Re: Control # 50985

November 15, 1974

Mr. Douglas M. Collins
Directorate of Licensing
Atomic Energy Commission
Washington, D.C. 20549

This is in answer to your letter of October 25, 1974, requesting additional details regarding amendment to our Byproduct Material License #29-05364-01. The numbered items correspond to the numbers in your letter.

TRANSMISSION OF COBALT - 60 GAMMA RAYS IN CONCRETE

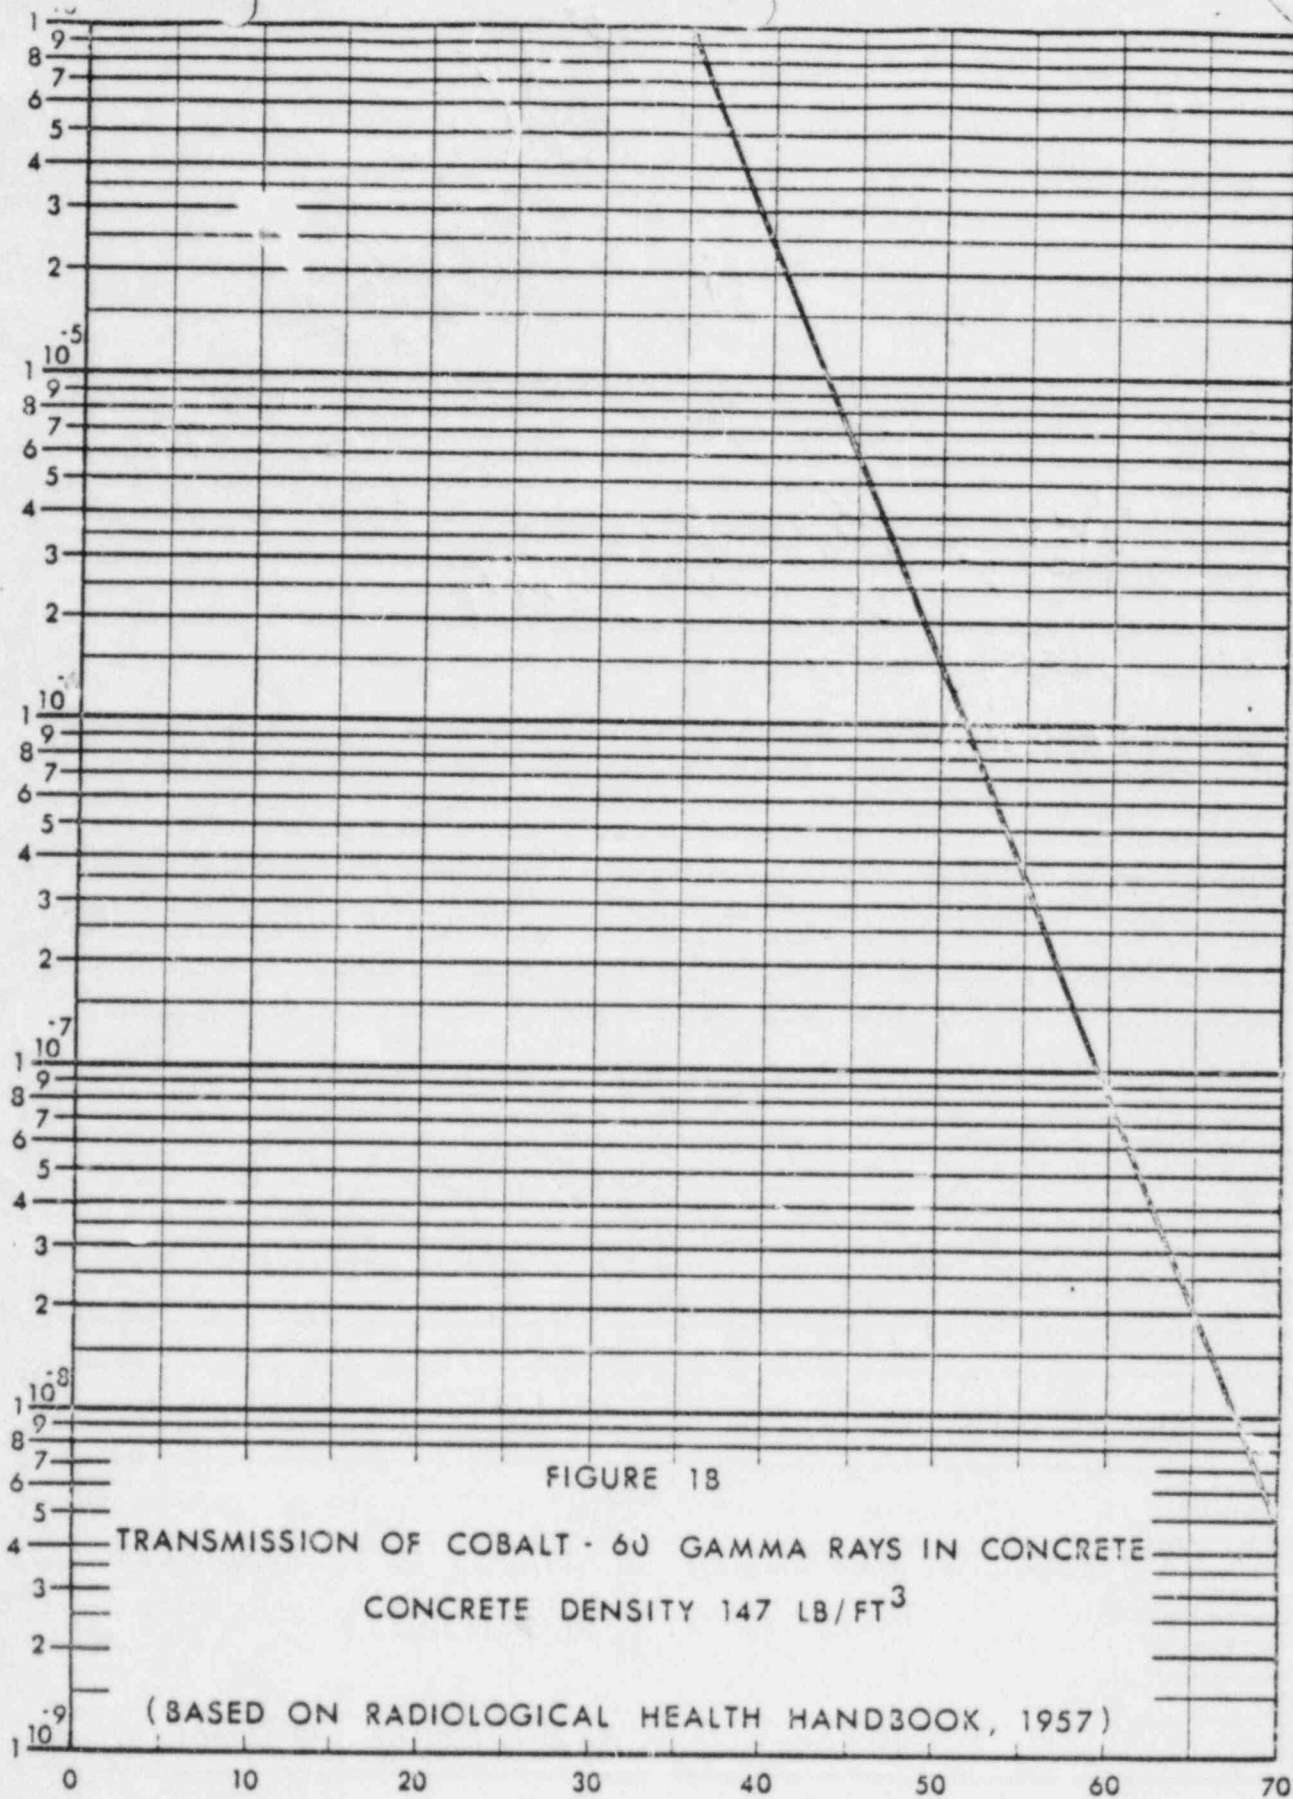
The transmission of Cobalt 60 gamma radiation in concrete is shown in Figure 1A, 1B. The exposure rate from a 1 curie point source of Cobalt 60 is 1.3×10^3 mR/h at 1 metre and varies inversely with the square of the distance. Concrete thickness for the primary shielding was determined by calculating the maximum exposure rate outside the shielding wall for a point source and correcting for source geometry and absorption within the source plaque. Some sample calculations are given below.

FIGURE 2
SCATTERING OF GAMMA RAYS
FROM SURFACE

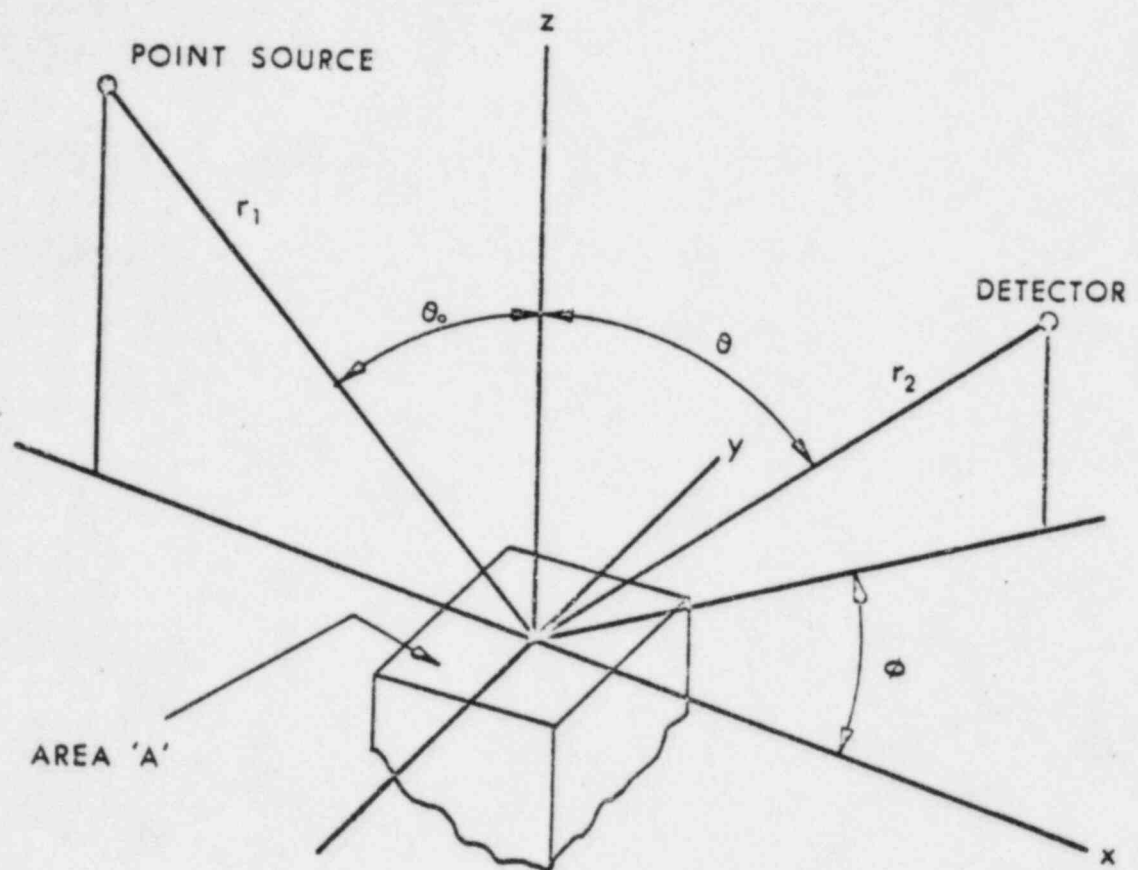
Maze entrances for Industrial Irradiators designed by AECL are based on both calculations and measurements. The radiation incident upon the maze walls due to singly-scattered radiation is calculated by dividing the scattering areas into small segments and calculating the amount of single-scattered radiation from each segment. The exposure rate from the small scattering area A (Figure 2) is given by:

GUIDE CABLE PLUG ASSY rec with letter history

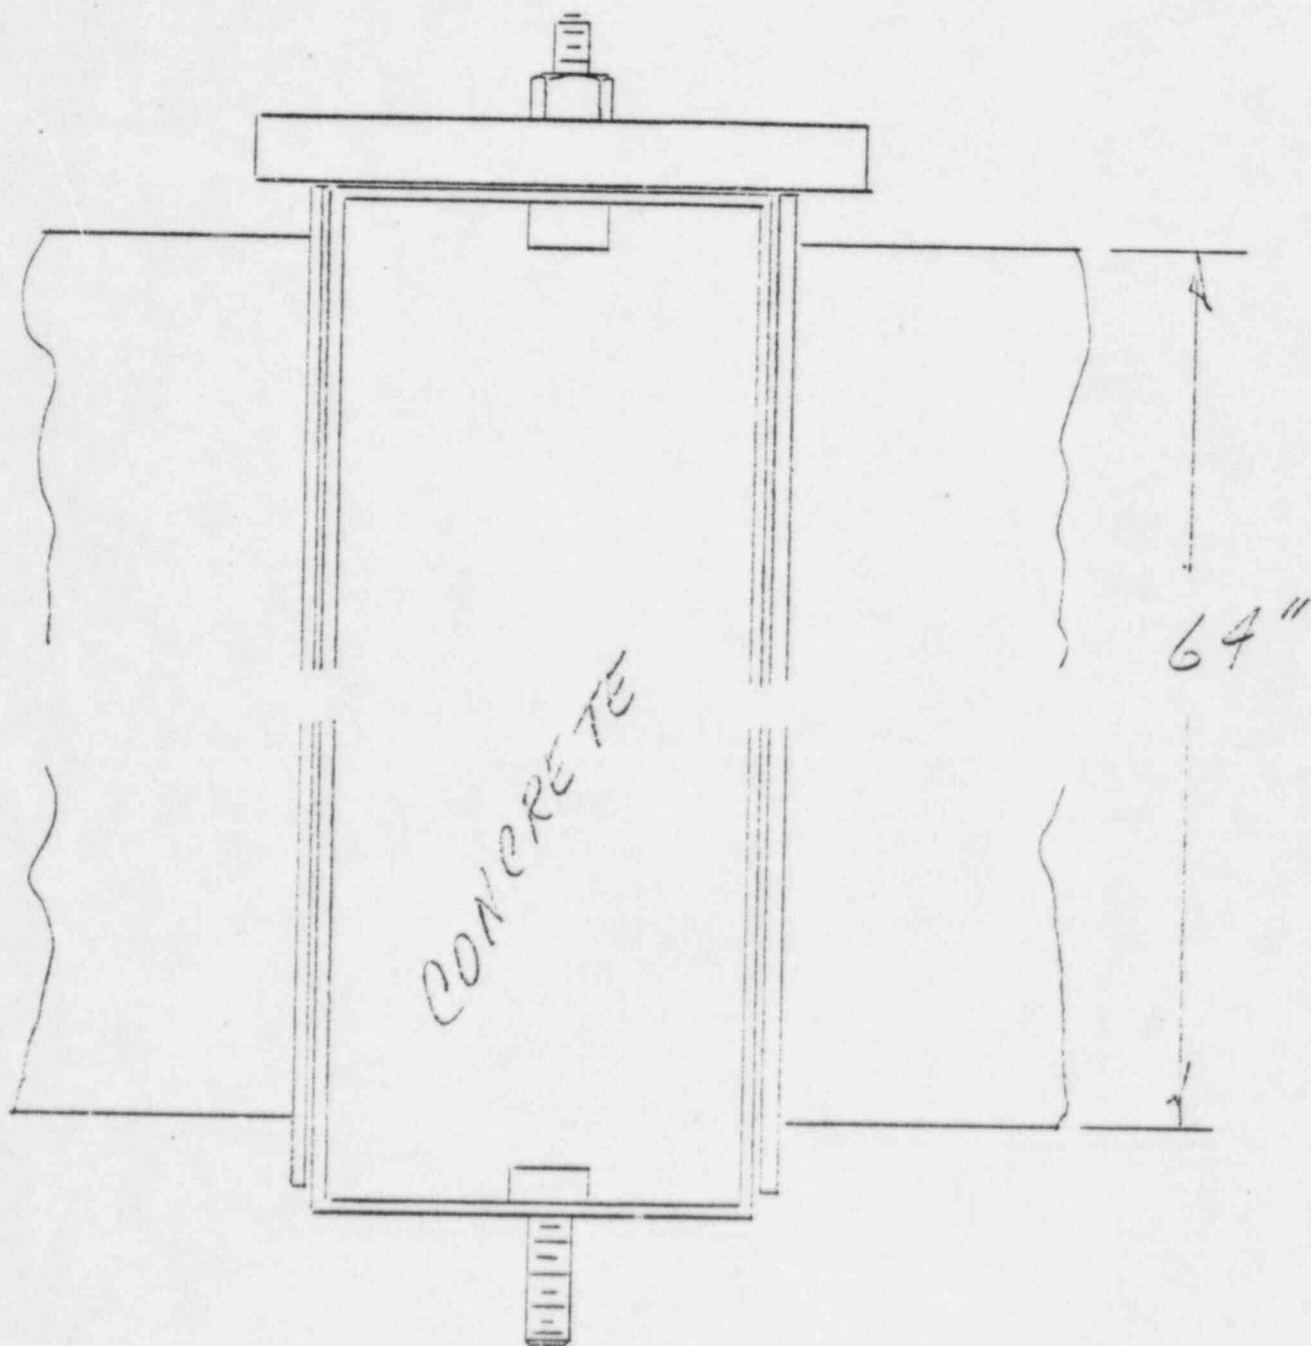
In the roof, slightly off-set from the vertical source rack, are three-three inch holes. (#16, Drawing 100618) Two source rack guide cables are attached in the two end penetrations to plugs shown in Enclosure 5. In the center plug (Enclosure 6) are two 3/8" holes, through which 1/8" stainless steel source rack cables pass, which raise or lower the source. A fixture on the roof of the cell, directly over this plug supports lead bricks 9" (or more) in thickness to attenuate possible radiation leakage. (Item #13 on Drawing 100618). Additional shielding can be added if needed.

PACKAGE SHUFFLE SYSTEM
CONCEPT

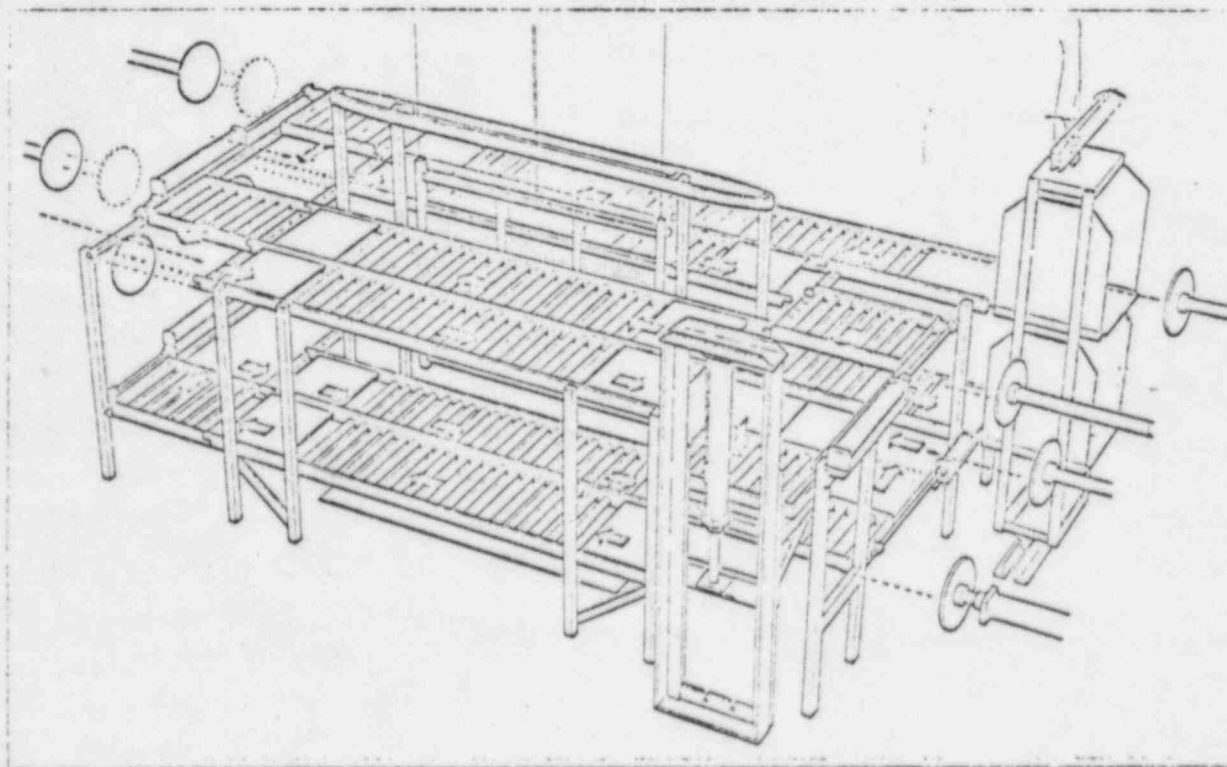
4. A sketch of the "Step 2" package shuffle system is shown in Enclosure 8. Movement of the product "tote" boxes is via pneumatic cylinders and elevators, with none of the pushing being done in a direct line to the source.

The tote boxes travel on rollers which roll in the direction of movement, and the boxes are contained along their base and top by steel channels which maintain the designated direction of travel. Enclosure 9 shows the method of operation of the shuffle system. The location of the source relative to the system is shown in Enclosure 8.
